Access Compliance Report Public Rights-of-Way (Curb Ramps)

Main Street: APRENDER_ST Cross Street: ANDAZA_ST Location: SE

ADA ID: RPRK211202133327 Ramp Type: Type 1 - Perpendicular Initial Pass/Fail: Fail Overall Compliance: No Severity Score: 2

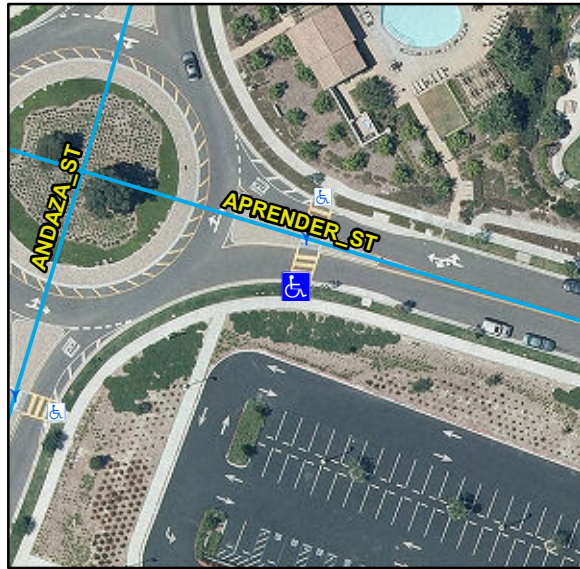
Compliance	Description	Data	Compliance	Description	Data
N/A	Ramp Length (in)	84	N/A	Flare Type LT	
Yes	Ramp Width (in)	60			N/A
Yes	Ramp Run Slope (%)	7.1	N/A	Flare Slope LT (%)	N/A
No	Ramp Cross Slope (%)	2.5	N/A	Flare Traversable LT	N/A
N/A	Landing Present	N/A	N/A	Flare Type RT	
N/A	Landing Length (in)	N/A			N/A
N/A	Landing Width (in)	N/A	N/A	Flare Slope RT (%)	N/A
N/A	Landing Run Slope (%)	N/A	N/A	Flare Traversable RT	N/A
N/A	Landing Cross Slope (%)	N/A	N/A	DWS Provided	N/A
N/A	Landing Movement Obstructed?	N/A	N/A	DWS Contrast	N/A
	Landing Movement Type	N/A	N/A	DWS Length (in)	N/A
N/A	Landing Shared	N/A	N/A	DWS Full Width	N/A
N/A	Clear Space	N/A	N/A	DWS Offset Left (in)	N/A
N/A	Clear Space To Crosswalk (in)	N/A	N/A	DWS Offset Right (in)	N/A
N/A	Marked Crosswalk 1	Yes	N/A	Marked Crosswalk 2	N/A
	Crossing 1 Direction	N		Crossing 2 Direction	N/A
	Marked Crosswalk 1 Width (in)	144		Marked Crosswalk 2 Width (in)	N/A

Remove & Replace Entire Ramp.
